I refer to the Department's below email of 13 November 2020 regarding the exhibition of the Environmental Impact Statement (EIS) for State Significant Development SSD-10448 Aspect Industrial Estate for earthworks, infrastructure and roads across the entire site, and the staged construction of warehouse and logistics facilities with associated car parking across 11 developable lots at Mamre Road, Kemps Creek (Lots 54-58 DP 259135) in the Penrith City Council Local Government Area (LGA). Submissions need to be made to the Department by 18 December 2020.

Endeavour Energy's further recommendations and comments are as follows:

## 5.2 Strategy 2 – Water Supplies/Utilities for Firefighting Operations:

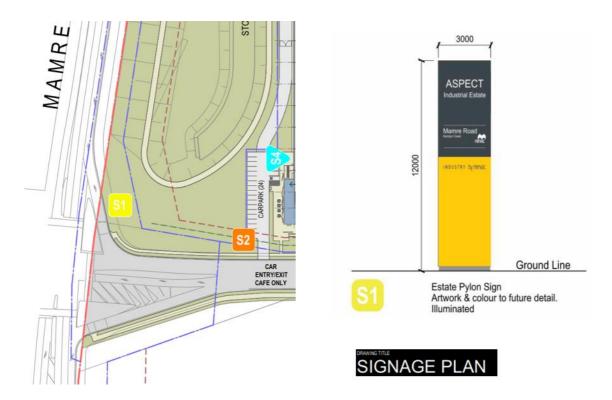
Electricity and gas supplies will be laid underground and therefore address the performance standard of Chapter 8.3.1 of *Planning for Bushfire Protection* 2019.

It is imperative that the access to the existing electrical infrastructure on and in proximity of the site be maintained at all times. To ensure that supply electricity is available to the community, access to the electricity infrastructure may be required at any time. Restricted access to electricity infrastructure by maintenance workers causes delays in power restoration and may have severe consequences in the event of an emergency.
